**ALLSTON MULTIMODAL PROJECT**  
**Multimodal Connections Overview**  
**Working Group Meeting**

December 19, 2024

# Multimodal Local Connections Feedback

# Franklin Street Pedestrian Bridge

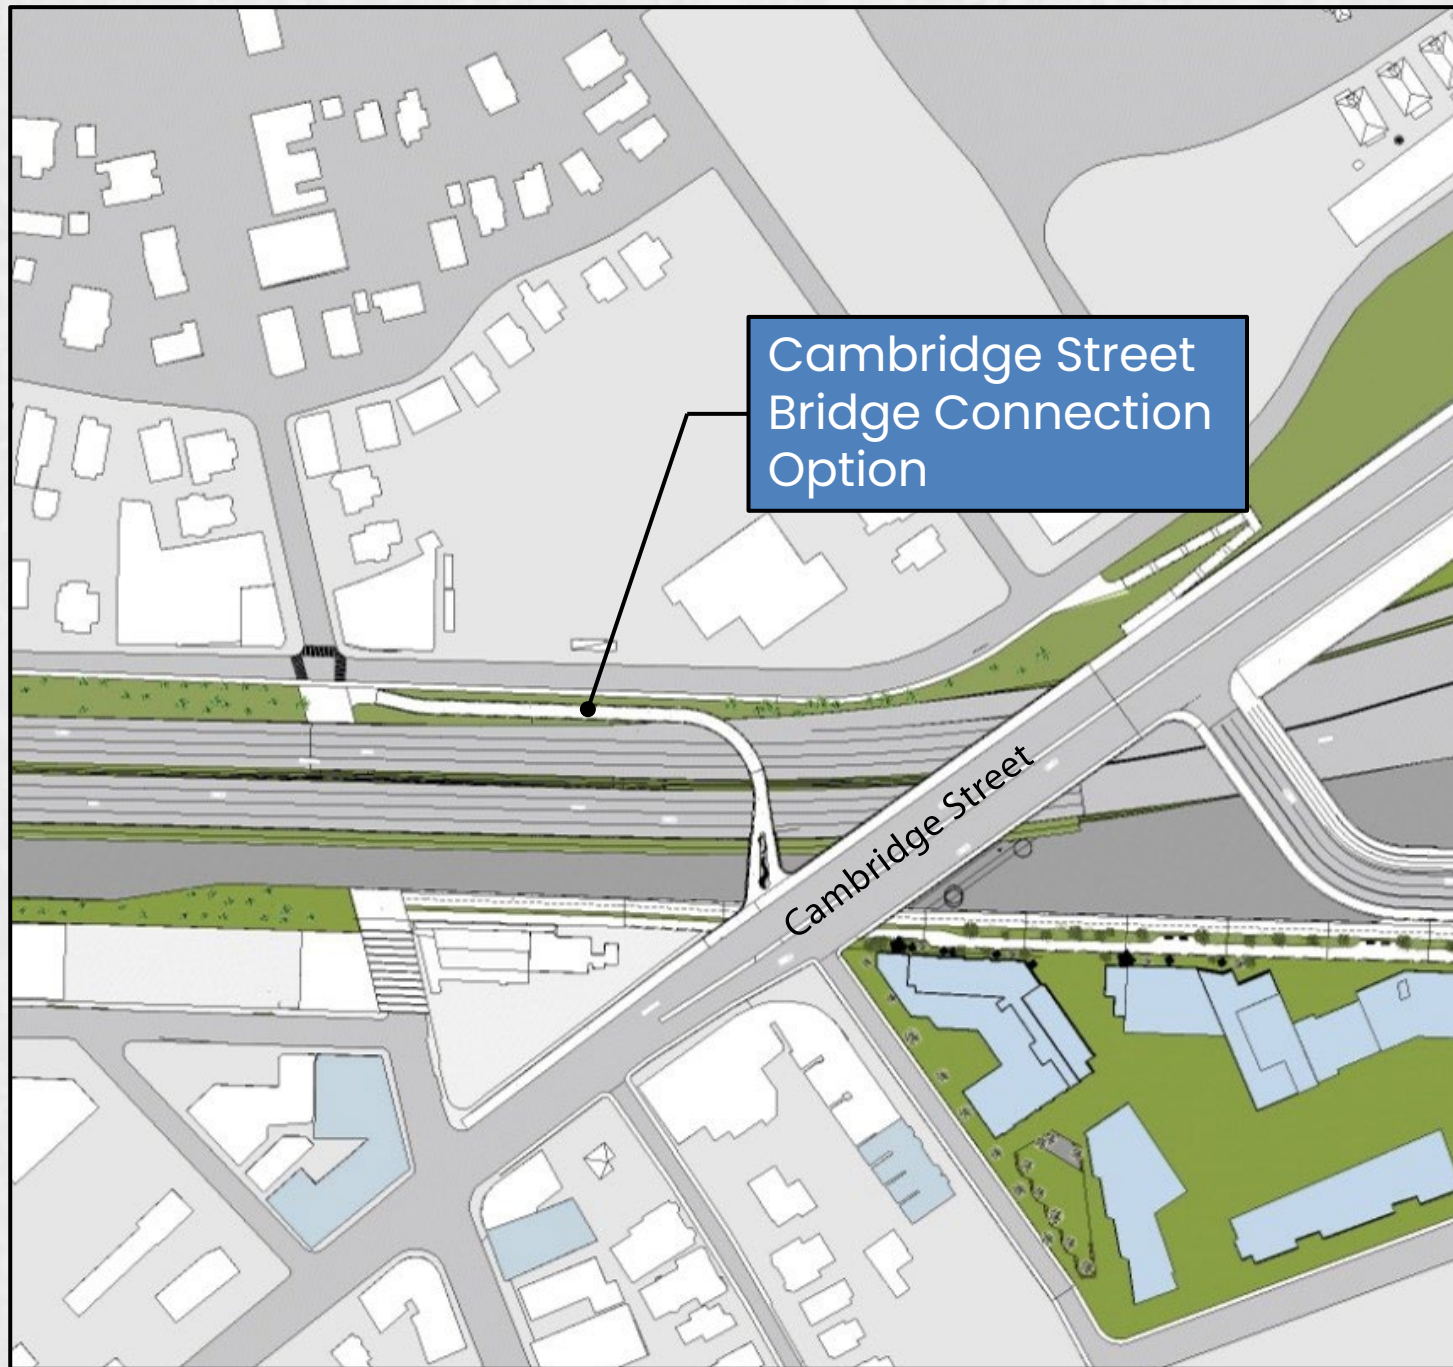
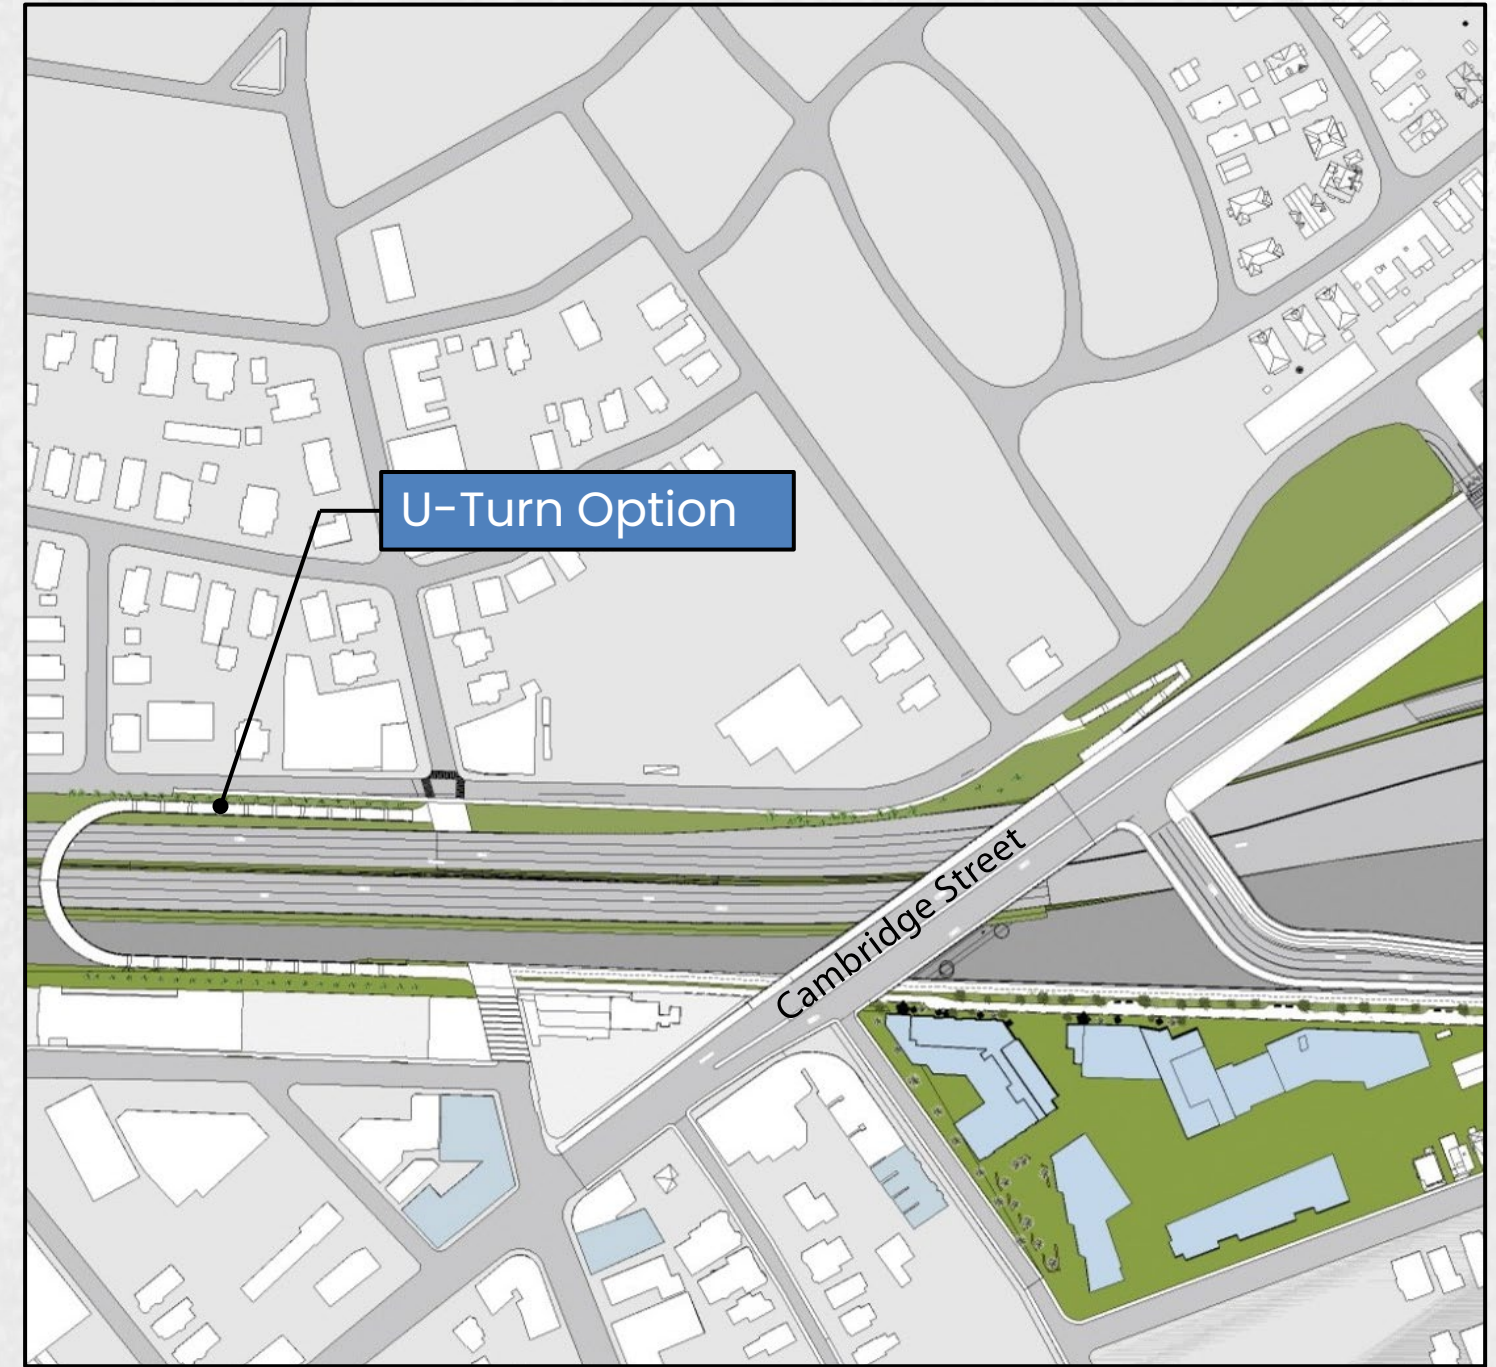
- Franklin Street Pedestrian Bridge
  - How many tracks between Boston Landing and Cambridge Street?
    - 3 Tracks
  - How close to I-90 can these tracks be located and how much can they be lowered?

- How much rail clearance is required above the pedestrian bridge?
    - 18'-6" (min.) is required per the MBTA due to freight and future electrification requirements. Clearance at Prudential Tunnel would be increased in the future by lowering rail profile.

- Current track layout positions the tracks as close to I-90 as possible to fit within rail bay below future Cambridge Street Bridge
    - Tracks can be lowered approximately 5 ft in the vicinity of the Franklin Street Pedestrian Bridge as currently designed

# Southside Buffer Path

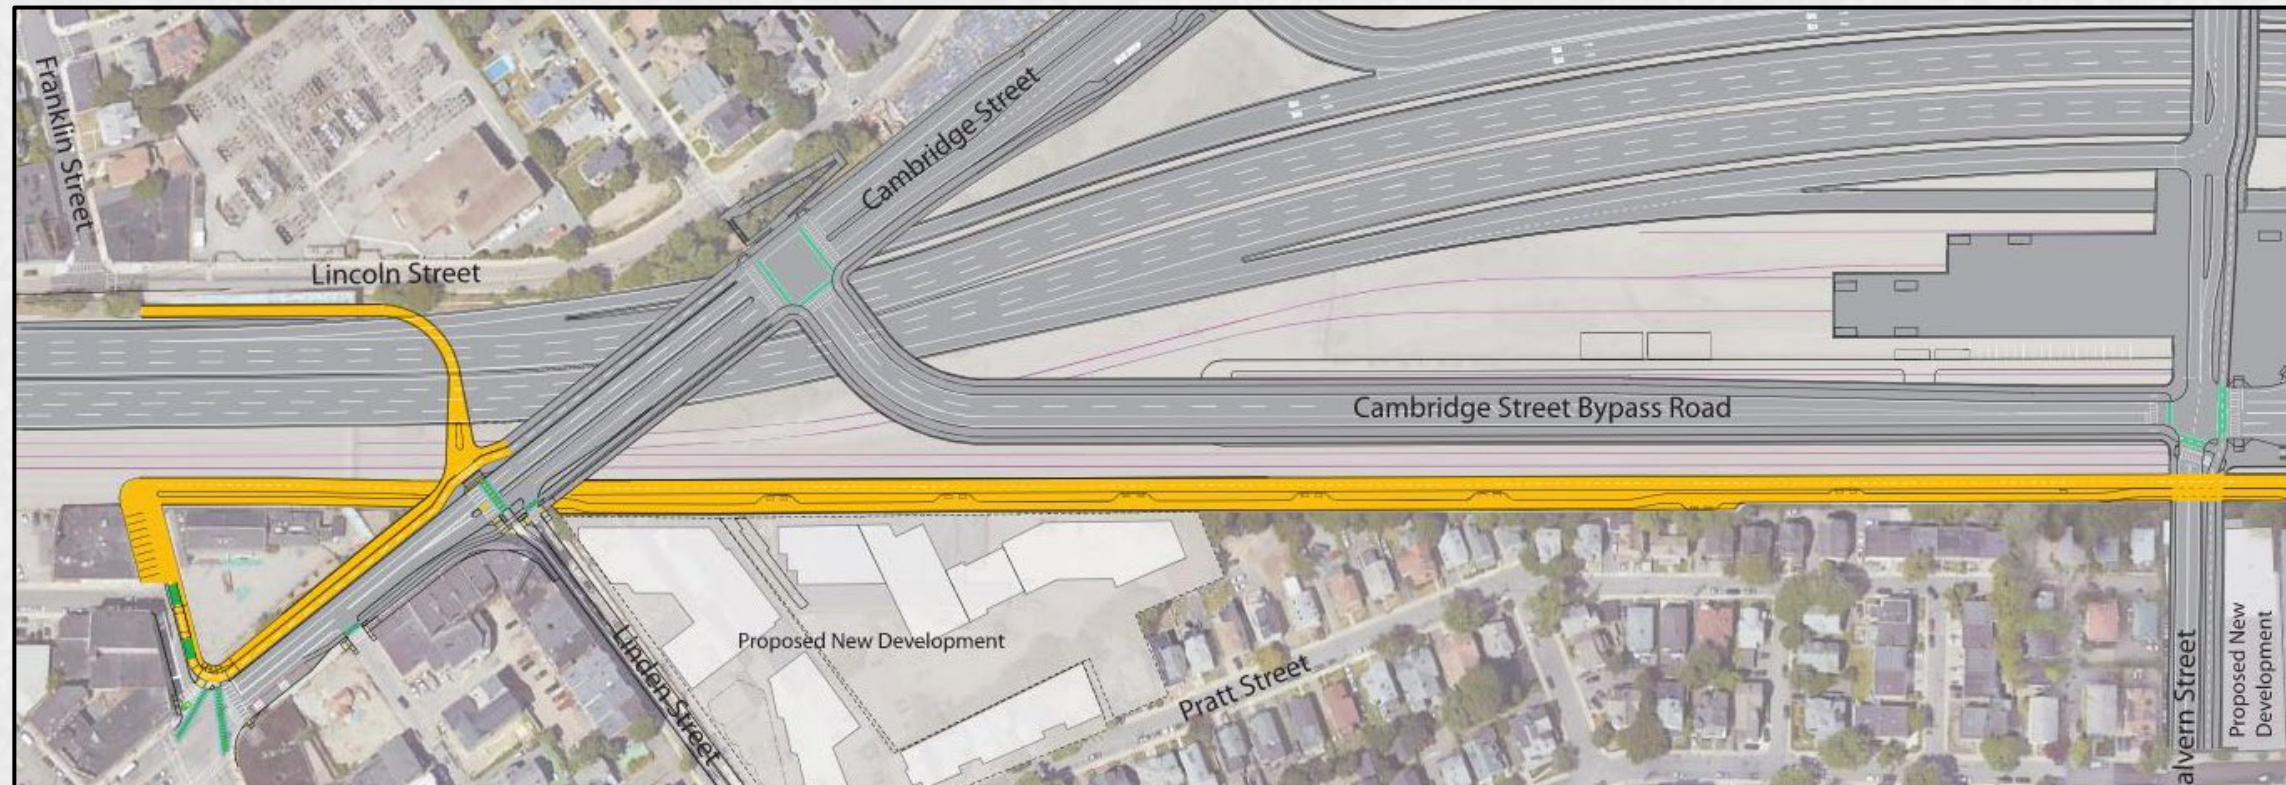
- Some of these design elements are to be developed in the future by others and will require city and state approvals
  - We appreciate your decision to widen parts of the People’s Pike to 38’. A width of 50’ for the entire park from Cambridge Street to Agganis Way would create space for separated walking and biking paths, shade trees and landscaping, benches, public art, and amenities.

- Southside Buffer Path will be 30 feet wide minimum with certain locations widened to 38 feet width if existing utilities can be accommodated

# Agganis-PDW Path Ped Bridge

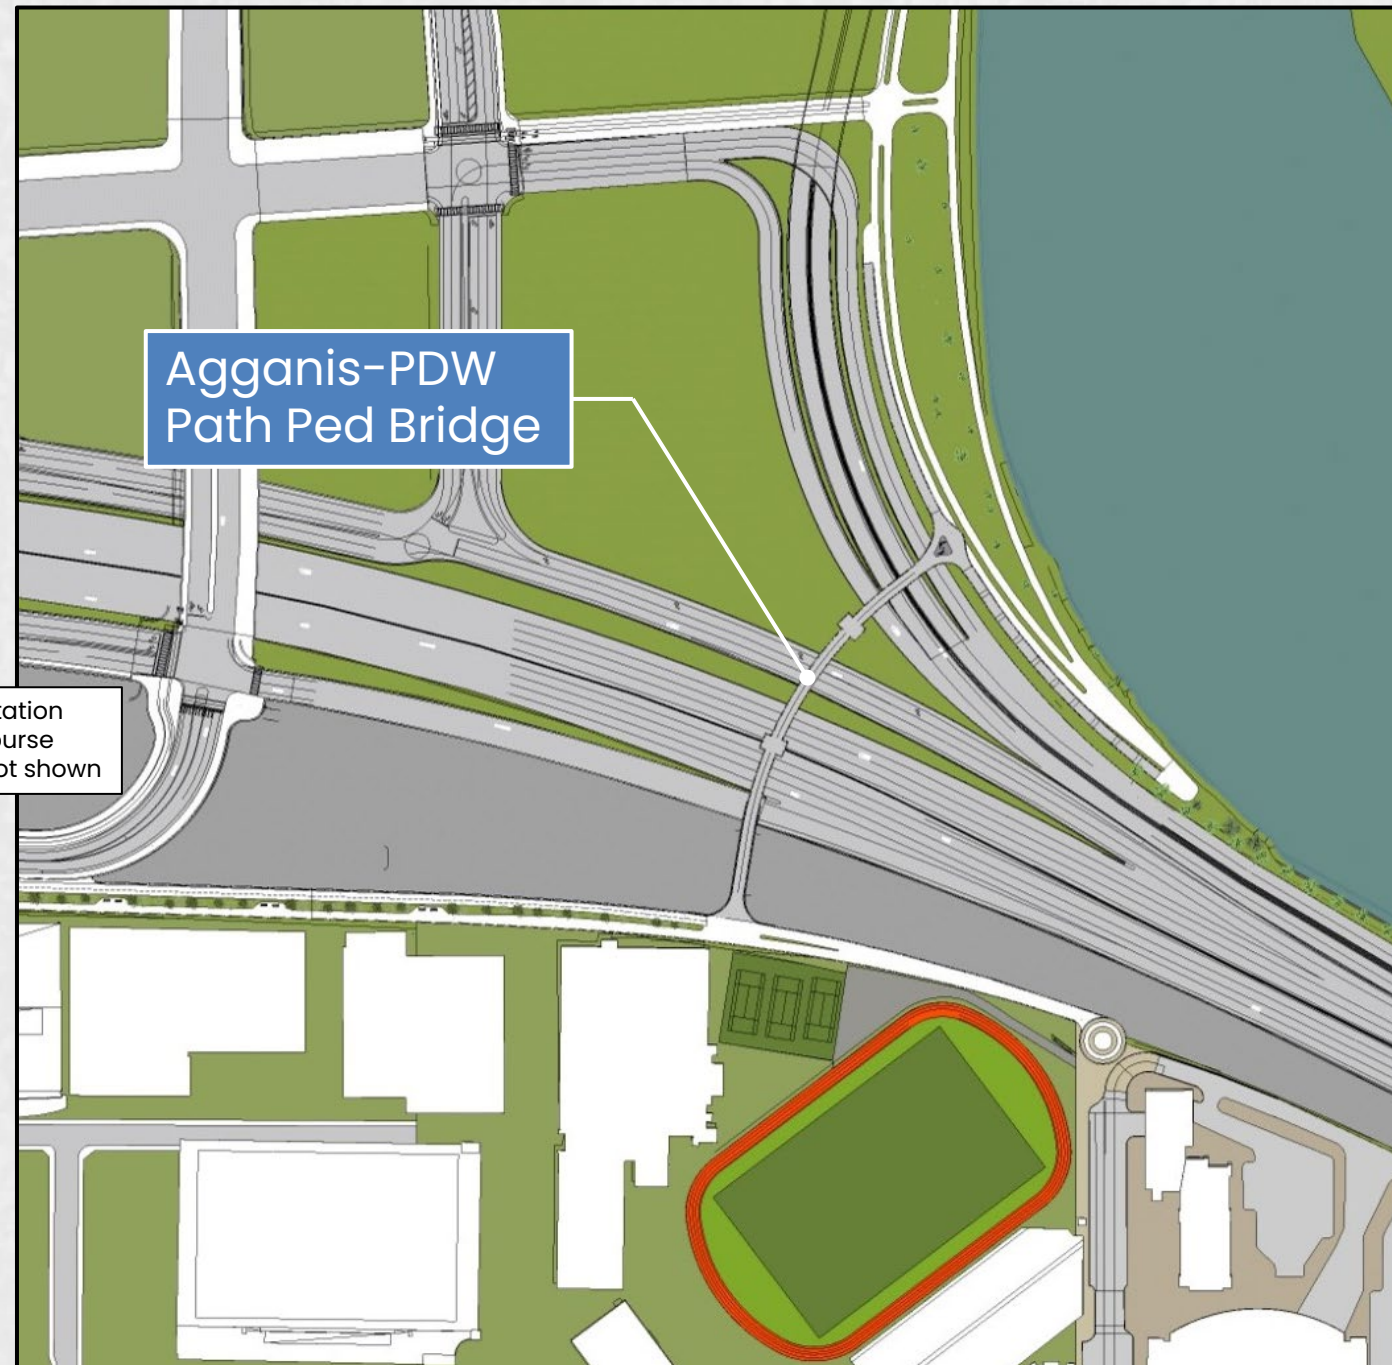
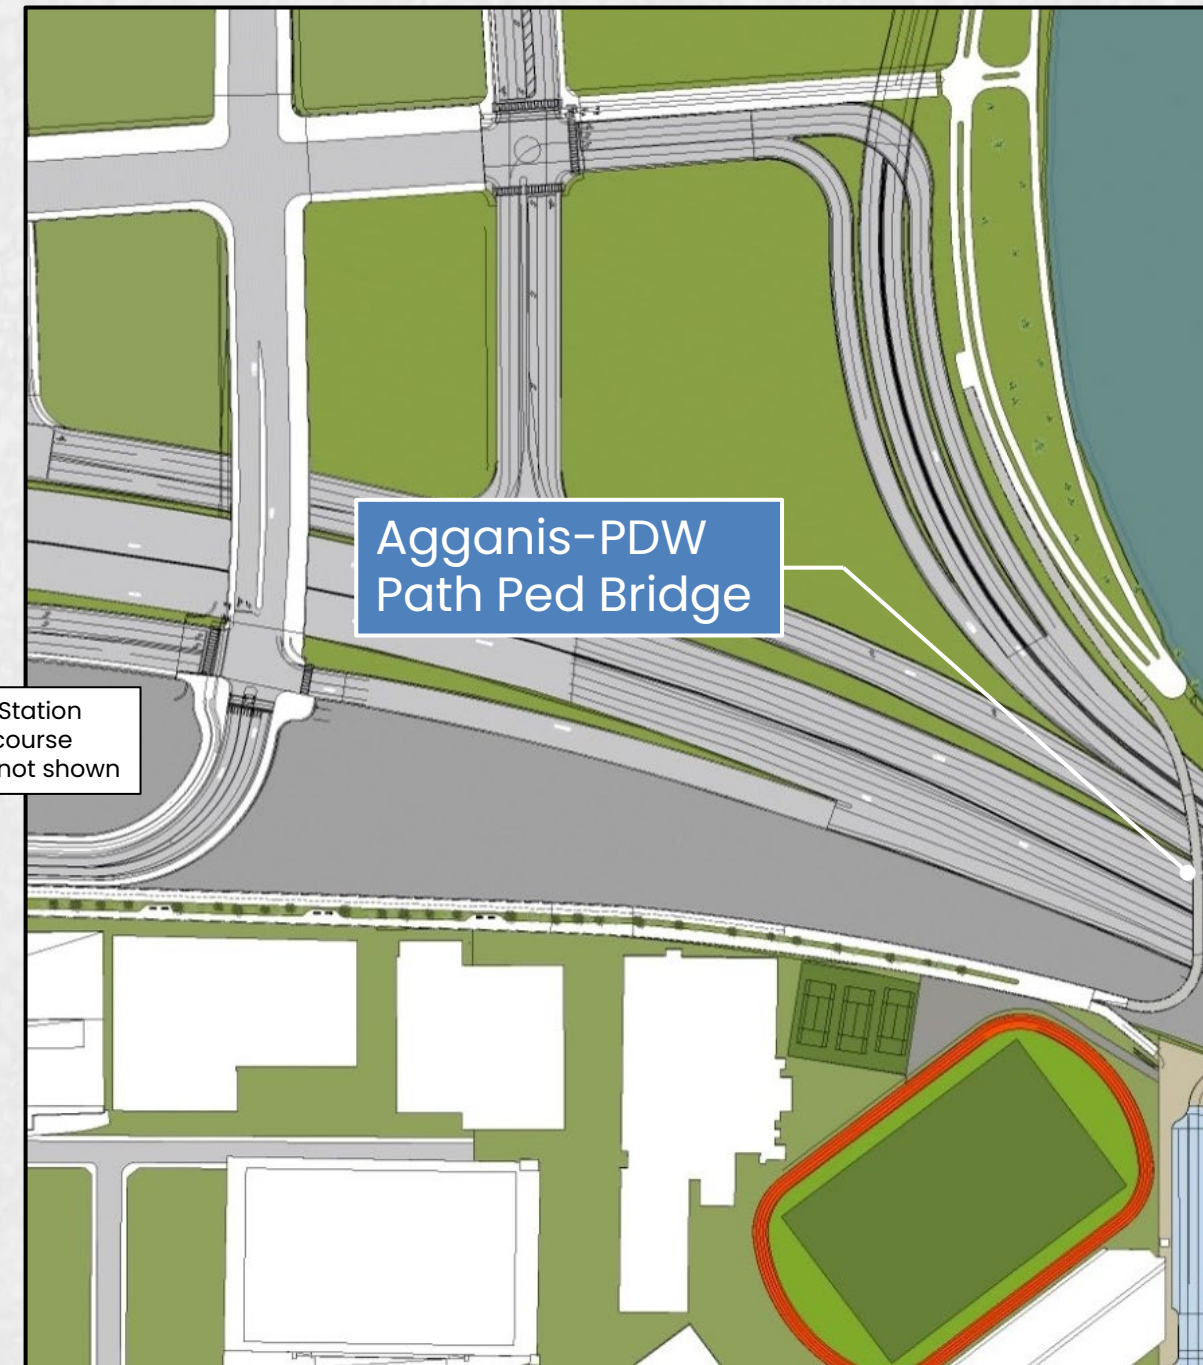
- Agganis–PDW Path Pedestrian Bridge
  - Options can only be compared after the number of Grand Junction and Worcester Line rail tracks and their vertical height has been resolved and MassDOT and the Working Group have collaborated with Boston University and the City of Boston to design the best possible connection near Nickerson Field and Agganis Way. The western option creates a long and isolated route over many highway lanes and rail tracks. Its urban design and adjacent air rights need more consideration.

- Rail track layout has been refined and a 3 or 4 track alignment at the Nickerson Field curve is no longer a differentiator between the East and West Options. Both pedestrian bridge options are now feasible with a 3 or 4 track layout.

- Similar to the Franklin Street Pedestrian Bridge, 18’-6” (min.) is required per the MBTA due to freight and future electrification requirements. Clearance at Prudential Tunnel would be increased in the future by lowering rail profile
